CONSTRUCTION SUMMARY

Grovetrail Developments Inc.

LOT NUMBER	PHASE	HOUSE TYPE	CLOSING DATE
30	1	BELVEDERE Elev A	31-Oct-22

SITE MASTER

LOT #30
38-11 ELEV "A"

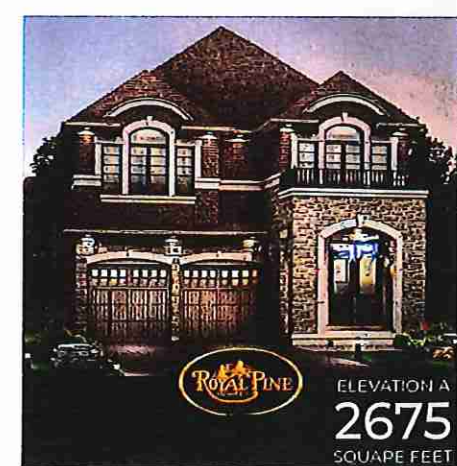
* 10' CEILING MAIN FLOOR

Cable - (C) (x2)
Telephone - (T) (x2)
Conduit (x1)

* Extended Height Double Doors (delete transom window)
